## ***Interactive comment on “DUACS DT2014 : the new multi-mission altimeter dataset reprocessed over 20 years” by M.-I. Pujol et al.***

**M.-I. Pujol et al.**

Received and published: 18 April 2016

Figure A :  $K^{-2}$  spectrum (dashed) is added to white noise (dotted) to simulate noisy data (black, plain). The green curve shows the PSD after a 10 km cut-off lanczos filter is applied. The blue curve shows the PSD after a 30 km cut-off lanczos filter is applied.

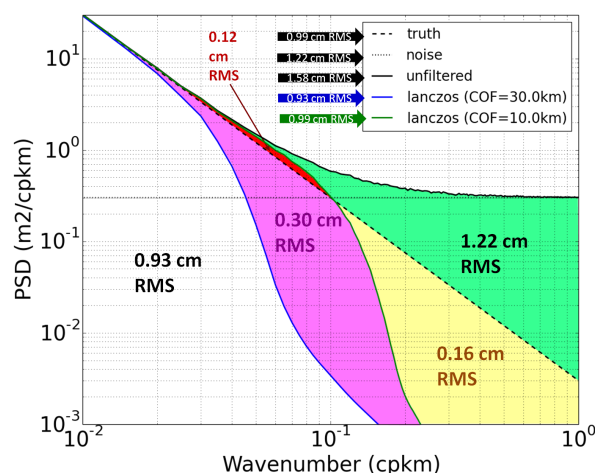
12. Referee : Page 11, lines 5-7: Defining the resolution of the along-track data as the point where the spectra of signal and noise intersect is too liberal. With a signal-to-noise ratio of 1, it is impossible to distinguish between signal and noise. In my experience, based on visual assessment of various fields with simulated noise added, a more reasonable choice is a S/N variance ratio of 10, which corresponds to a signal standard deviation that is about 3 times larger than the noise standard deviation. At a minimum, a S/N standard deviation ratio of 2 is needed to distinguish signal from noise (i.e., a S/N variance ratio of 4).

We illustrate the rationale for choosing this cut-off value in Figure A. We simulated proxies of SSH following a simple K-2 law (0.99 cm RMS) and added white noise (1.22 cm RMS) to get noisy SSH samples (1.58 cm RMS). The noise floor was set so that both PSD intersect at 10 km exactly.

Following our SLA filtering method, we used as 10 km cut-off lanczos filter (green curve). As a result the smoothed topography has RMS of 0.99 cm and we removed 1.22 cm RMS of high-wavenumber signals. As expected, the filter is not perfect: we destroyed a small fraction of signal (yellow zone, 0.16 cm RMS) and we left a small fraction of the noise (red zone, 0.12 cm RMS). Figure B shows on an arbitrary sample that the filter is not perfect but generally consistent with the truth. This is why we consider this point as the smallest cut-off frequency if one wants to preserve as much signal as possible.

In contrast, we also used a 30 km cut-off filter (SNR = 10) to illustrate the difference. Figure A shows that we better smoothed out noise (red region = 0.12 cm RMS). Unfortunately we also smoothed the true signal up to 50 km (pink region, 0.3 cm RMS). The net result is therefore negative (hence 0.93 cm RMS after smoothing). Figure B shows that we did lose many small scale features that were partially observed and that could have been used.

The point where both effects (oversmoothing of true signal in pink zone VS. lack of smoothing of noise in red zone) balance out is between SNR=1.2 and SNR=1.3 (here 11-12 km). The 10 km filter (SNR=1) is slightly better if one wants to preserve the signal, and the 11-14 km filter is better if removing noise is more important. In practice, in a sample like Figure B, the difference is very difficult to see. Using a larger cut-off wavelength should be used only if perfect noise removal is the highest priority (read: to
